Arboricultural Report

Proposed development
Land between Clay Lane and Sagars Road
Handforth
Cheshire

*For the purpose of evaluating a report submitted in accordance with
BS5837:2012 Trees in Relation to design, demolition and
construction: Recommendations to support the development.*

Handforth Parish Council

Map 1

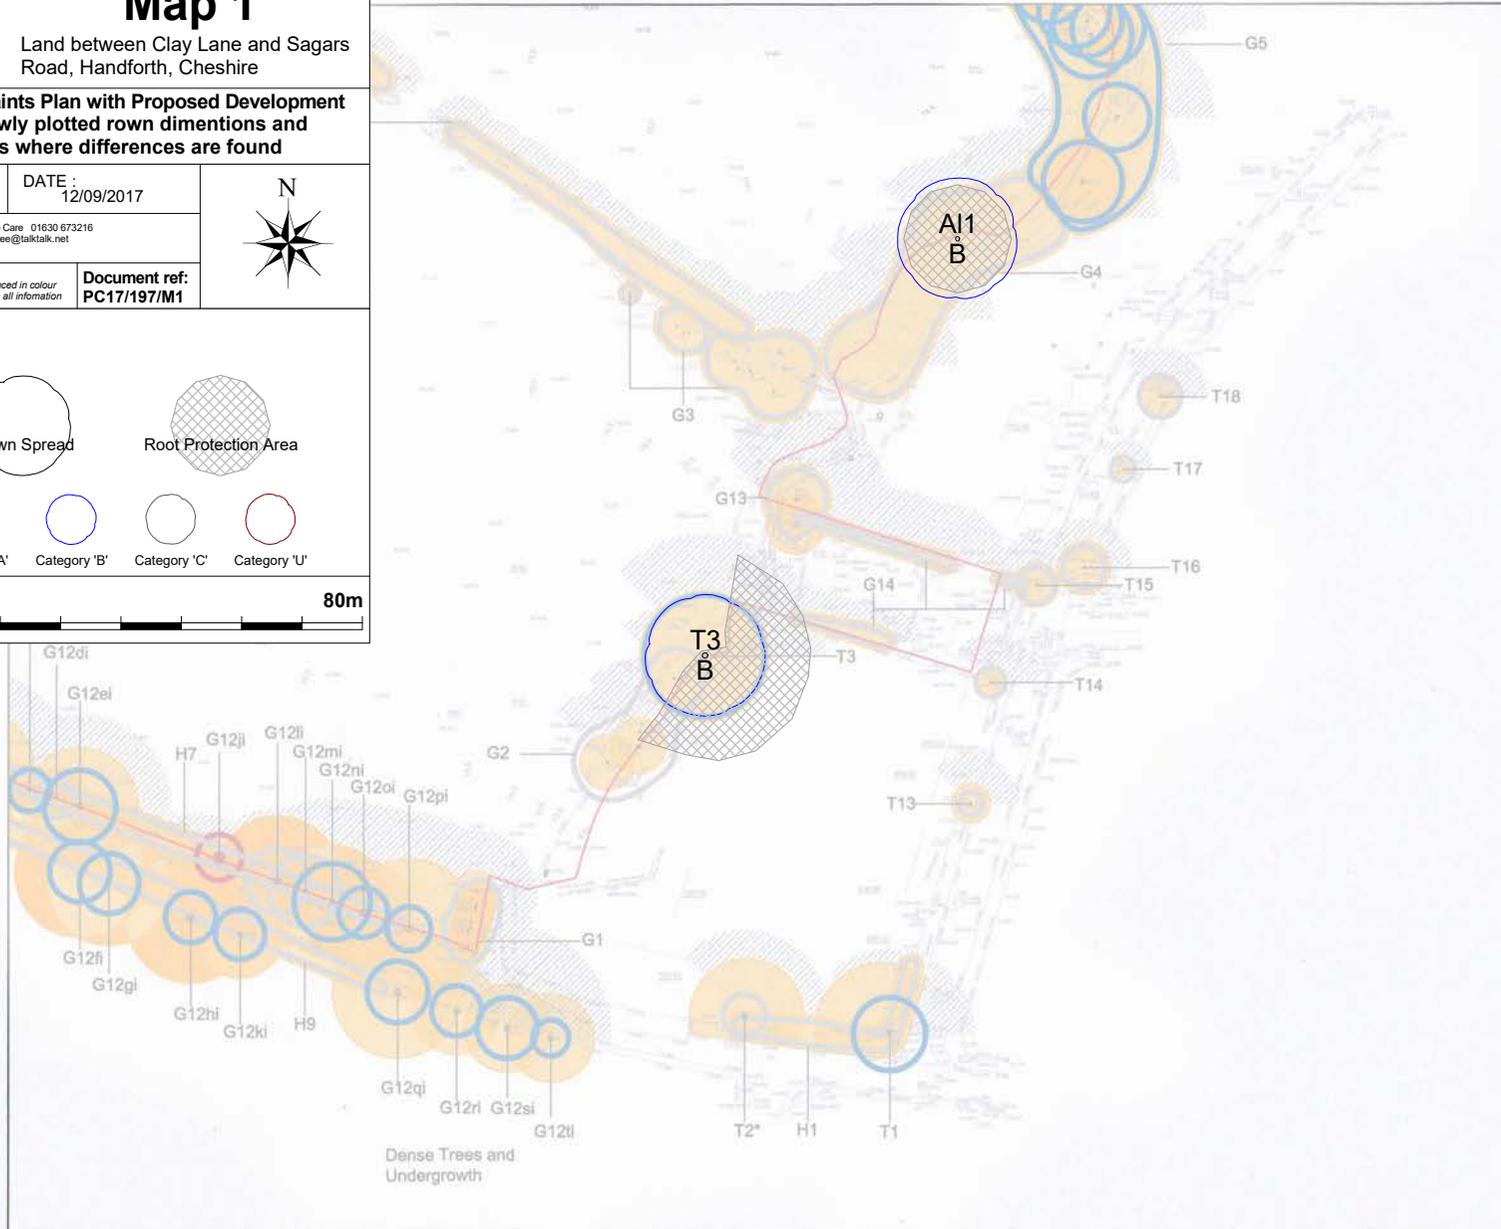
- 7.7 The plans appear to show the access road entering the site through 15 Hampson Crescent and over Dobbin Brook into the site. The RPA is drawn as a circle on the original plan, however the presence of the steep bank into Dobbin Brook will provide an effective barrier to root growth. The diameter of the tree has been estimated, due to the difficulties and implication of access in the original report. This tree measures 1060mm in diameter, somewhat larger than the 890mm estimated in the report. This diameter of tree requires an RPA of 509m² not 359m² as specified in the original report. Map 1 shows the likely distribution of the 509m² RPA, indicating a significantly large amount of the RPA within the garden of 15 Hampson Crescent (12%) where the access road is to enter the site. Damage to the tree roots may cause structural and health issues for this visually important and mature specimen. This tree is visible from much of Hampson Crescent and Meriton Road providing a large and visually important tree.

- 7.8 No details on how the Dobbin Brook is to be bridged have been supplied with the planning application. No explanation is available to show how T3 will be protected through installation of the access route. The Planning and Affordable Housing Statement supplied suggests at 1.4 in its executive summary “The proposed access design has already been endorsed by the local highways authority and considered by the Local Plan Inspector through the examination for the Cheshire East LPS”. With respect, both of these institutions are only able to judge the information put before them and that supplied by the original tree report into this development is lacking in regards to how Dobbin Brook can be spanned by a highway without causing damage to the large ash tree T3, 12% of its RPA being in the garden of 15 Hampson Crescent.

- 7.9 It is not clear whether access into the site can be achieved through this corridor whilst retaining T3, given level changes on site. A large amount of detail is required here. It may be that access from a different access point is a more workable solution.

Map 3

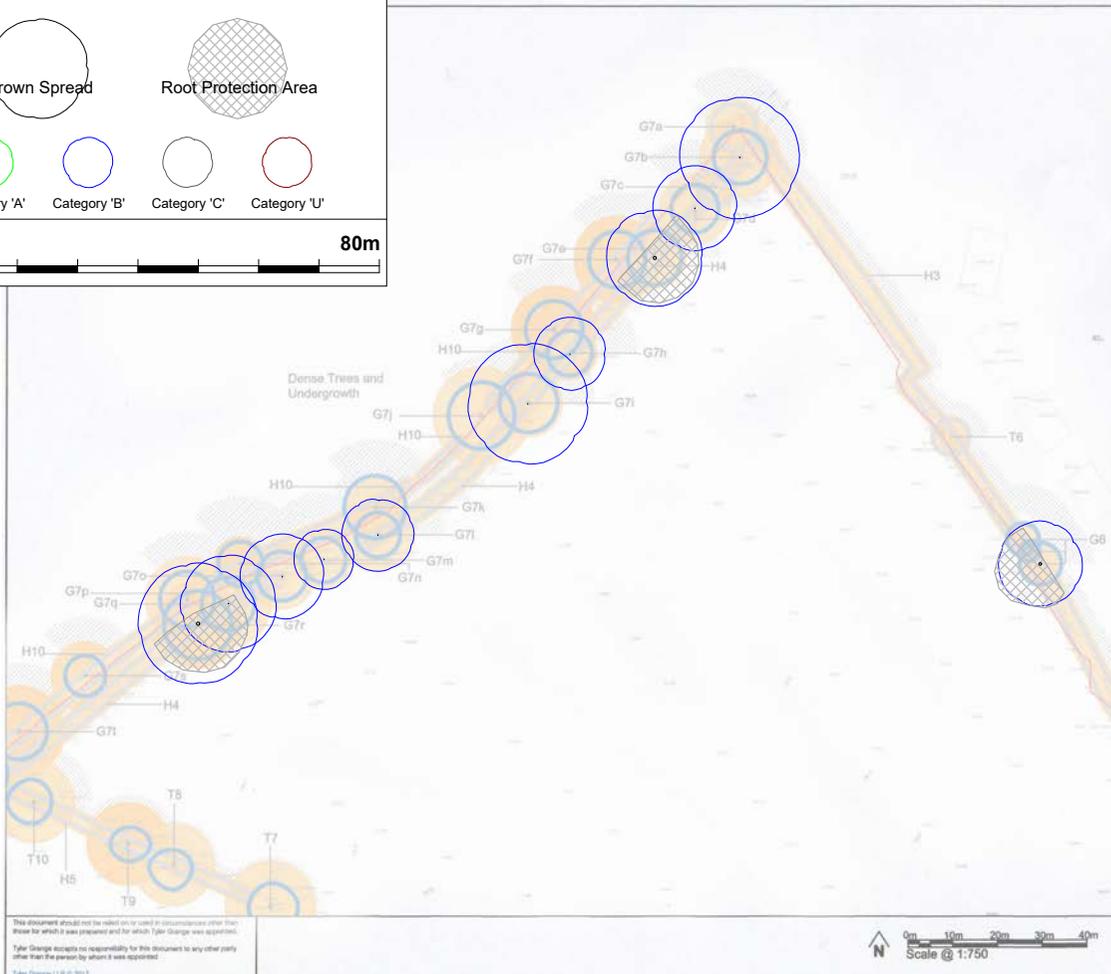
- 7.2 The grouping of trees in G7 (Map 3) has not sufficiently recorded crown dimensions. The presence of Clay Lane has not been taken into account when plotting RPAs. On my map I have plotted the crowns as a circle to the size where they overhang the site. Given the unmetalled nature of Clay Lane, I have plotted RPAs as reaching into the middle of the lane, as some roots are likely to be found here or reaching across the road. It appears that crown size causes much more of a constraint on many of these trees. It appears that there would be many conflicts between infrastructure and houses shown on the Tree Loss and Impact Plan, indicating the proposed development.

- 7.12 In the north-western corner of the indicated site lay out plans it appears that the aerial map used as a base line has either been altered, or is considerably out of date. The crown sizes of G7b, G7c, G7e, G7h, G7i and G7l are not that of which is shown in current aerial mapping or that which is recorded by myself. There is significant overlap between the built environment and tree crown spread.
- 7.13 In short, the majority of data recorded is correct with some problems occurring with over-generalisation of groups, a poor recognition of tree health/structure and inaccuracies from estimation. In some cases, serious problems from trees and future users of the site will occur should development be attempted whilst relying on the findings of the original tree report.

Map 5

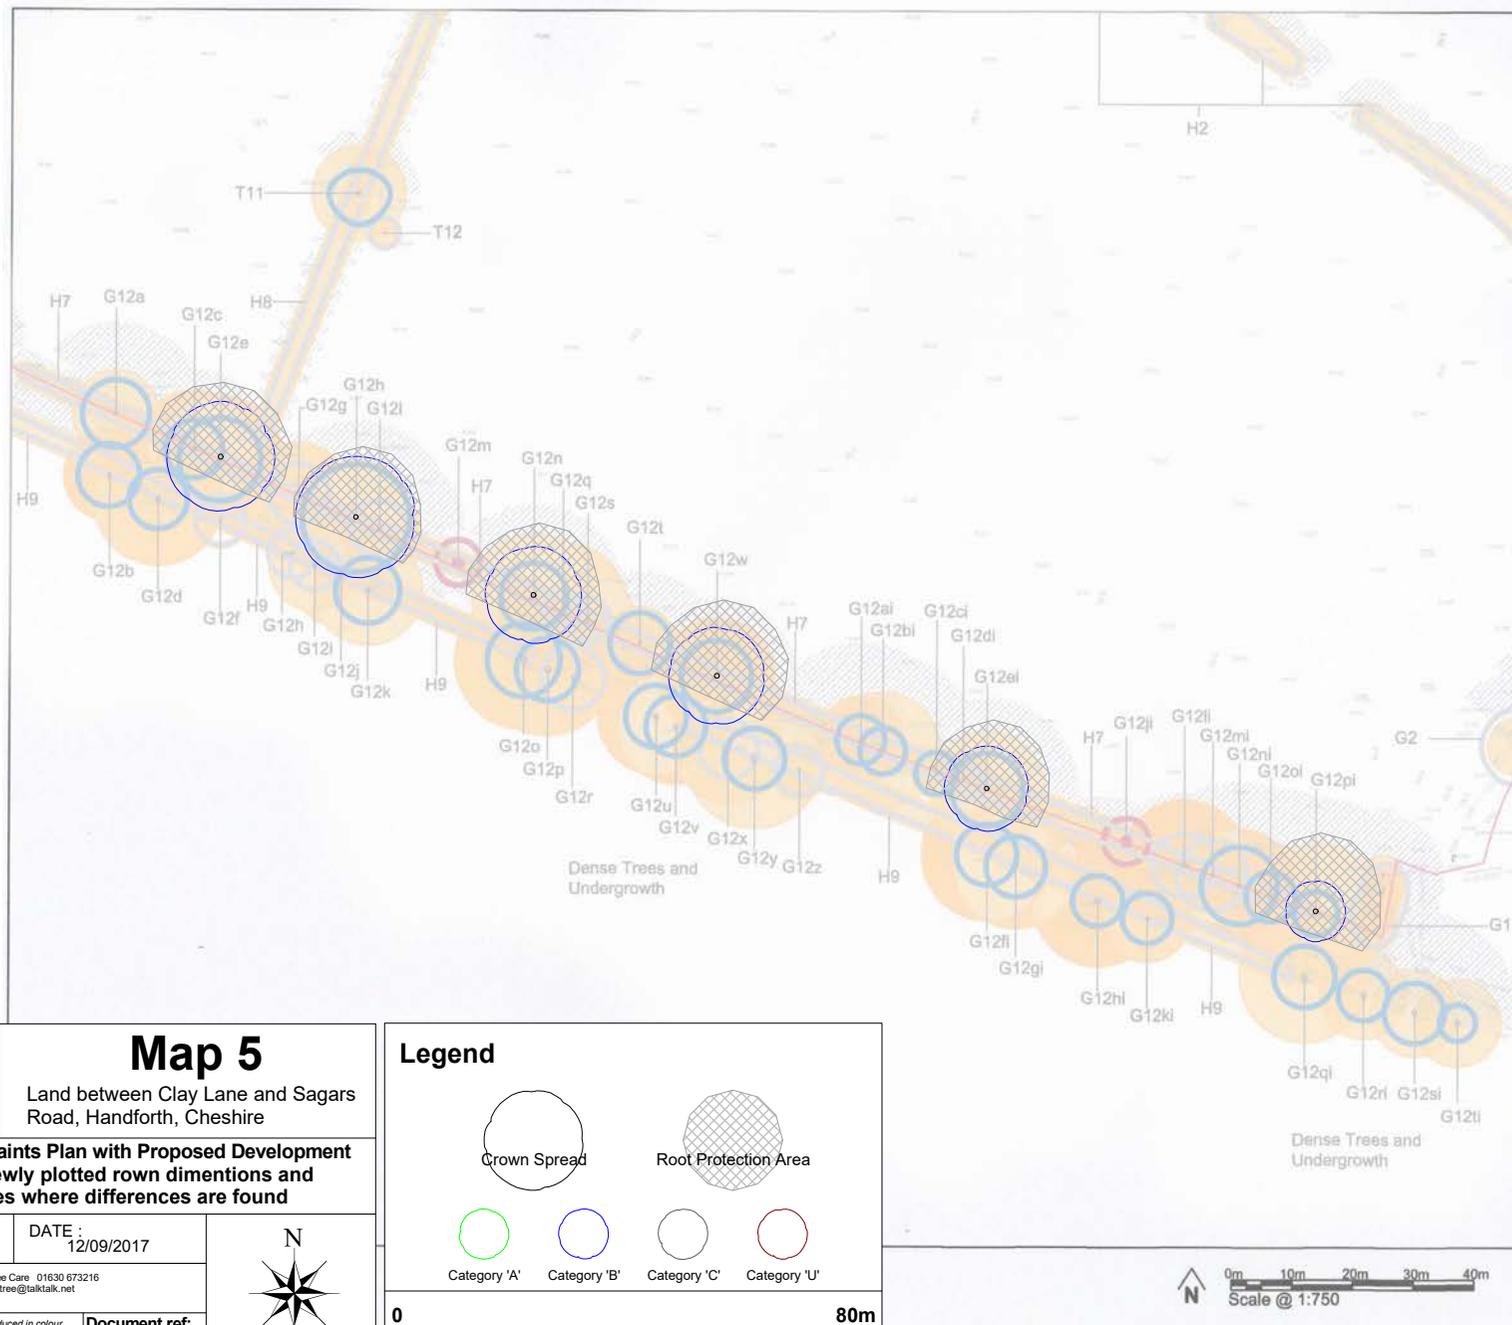
- 7.6 Grouping in G12 has not, in a similar way to G7, paid sufficient attention to some of these trees which have good form and have a high amenity value. Map 5 shows a similar arrangement as set out in Map 3, with a similar relationship between Sagars Road and RPAs adopted. Crown spread into the field is again underrepresented in the original report, but RPA spread seems to be the main area of constraint on this row of trees. Conflict between trees and the proposed development is likely here.
